SP09-2021 R3

• Schüco ASE 80.HI – Blendrahmen M9649505 und M9649506

- **Schüco ASE 80.HI – Outer Frame M9649505 and M9649506**

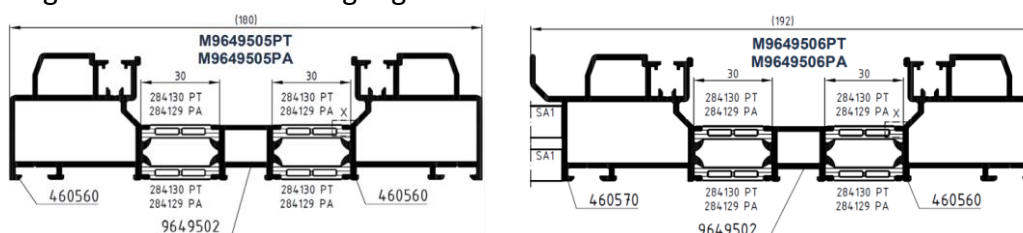
Als Alternative zu den Blendrahmen 487910 und 487920 für 2-gleisige Anlagen stehen folgende Profile zur Verfügung:

Die Profile können mit den Artikelnummern M9649505PT/M9649505PA und M9649506PT/M9649506PA erfasst werden. Die Profile werden in SchüCal als Kundenverbund (KV) Profile geführt.

Zum Verrollen der Alternativvariante sind spezielle Rollen und Rollenpläne erforderlich.

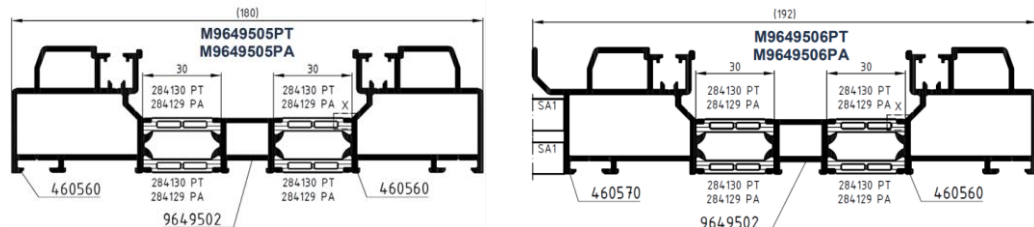
The following profiles are available as an alternative to frames 487910 and 487920 for 2-track systems:

The profiles can be entered with the article numbers M9649505PT/M9649505PA and M9649506PT/M9649506PA. The profiles are managed in SchüCal as “rolling by customer (KV)” profiles.

For rolling the alternative variant, special rolls and roll plans are required.
